Re: State of Tennessee perspective on letter from John A. Mullis to Andrew R. Wheeler dated April 5, 2019, Appeal of U.S. Environmental Protection Agency's Region IV position regarding water discharge limits for radionuclides

Re: State of Tennessee Position in the Formal Dispute Initiated by the U.S. Environmental Protection Agency on August 24, 2018, on the *Focused Feasibility Study for Water Management for the Disposal of CERCLA Waste on the Oak Ridge Reservation, Oak Ridge, Tennessee (DOE/OR/01-2664&D2)*

RE: Focused Feasibility Study [FFS] for Water Management for the Disposal of CERCLA Waste on the Oak Ridge Reservation, Oak Ridge, Tennessee (DOE/OR/01-2664&D2)

Explanation of Significant Differences for the Record of Decision for the Disposal of Oak Ridge Reservation Comprehensive Environmental Response, Compensation, and Liability Act of 1980 Waste, Oak Ridge, Tennessee (DOE/OR/01-2322&D1)

Figure 4.14. Mean concentrations of mercury in rockbass from BCK 3.3, redbreast sunfish from BCK 9.9, and rockbass from the Hinds Creek reference site (HCK 20.6) 1990 – 2014.

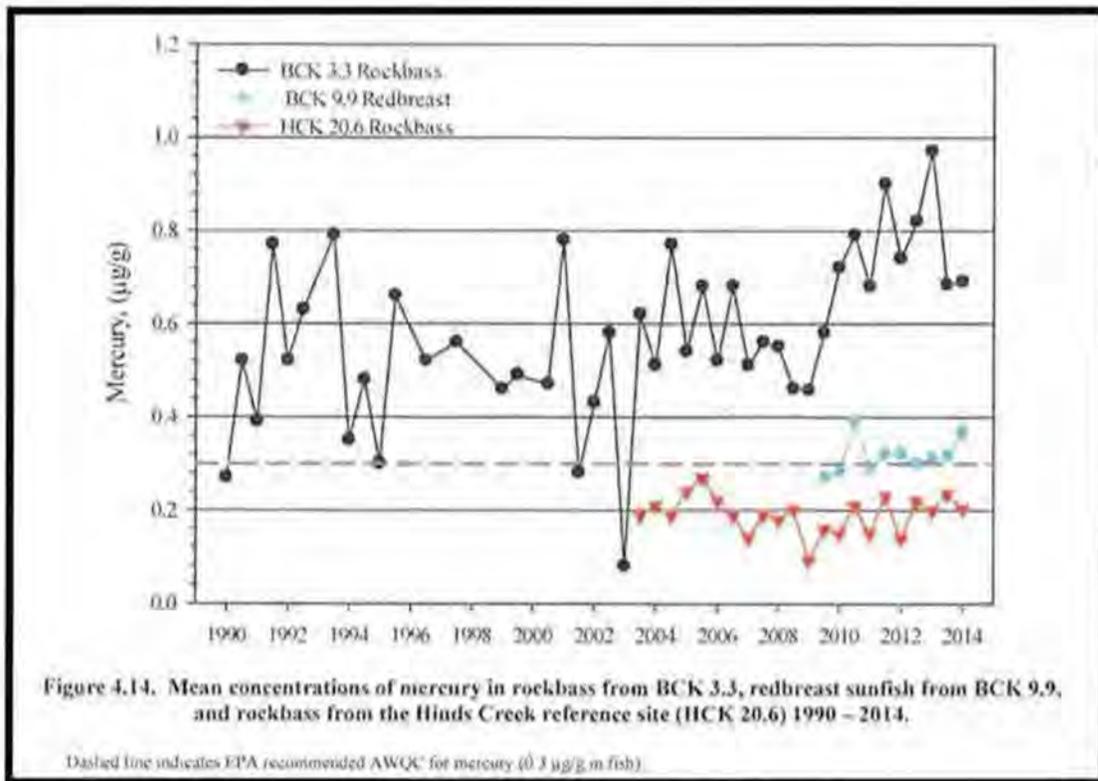
Bear Creek and downstream surface water are classified for recreation (e.g. fishing and fish consumption) and other uses and impaired water quality in Bear Creek is not a new issue. Bear Creek continues to be included on TDEC's Division of Water Resources 2017 proposed final year 2016 303(d) list due to mercury and other pollutants. Figure 4.14 of the 2015 Oak Ridge Department of Energy Remediation Effectiveness Report, shown below, graphically represents mercury concentrations in fish (Rockbass at BCK 3.3 and Redbreast at BCK 9.9) downstream of EMWMF in Bear Creek over time. HCK 20.6 is a background reach used for comparing mercury concentrations in Rockbass.

This graph indicates something changed after 2009 causing an increase in concentrations of mercury in downstream Rockbass. The data show that four of eleven samples (36%) collected since 2009 are greater than or equal to the highest levels observed since 1990. This trend is disturbing in light of the fact that DOE proposes to construct another disposal facility in Bear Creek Valley that would potentially receive additional mercury bearing waste from demolition of facilities in the West End Mercury Area (WEMA) at Y-12.

TDEC will not be issuing specific comments on the subject ESD at this time because of the unresolved issues of the disputed FFS that will likely result in changes to the ESD. Given that mercury has been and may be continuing to be discharged above allowable limits and mercury accumulation in fish from Bear Creek shows an increasing trend as opposed to decreasing, it is TDEC's position that DOE develop the following:

- 1) A detailed schedule for resolution of issues associated with water management at the EMWWMF and proposed EMDF; and
- 2) Discharge limits for chemical and radiological contaminants that are consistent with CERCLA, DOE Orders and ARARs; and
- 3) A plan to identify and correct discharges of mercury above allowable limits.
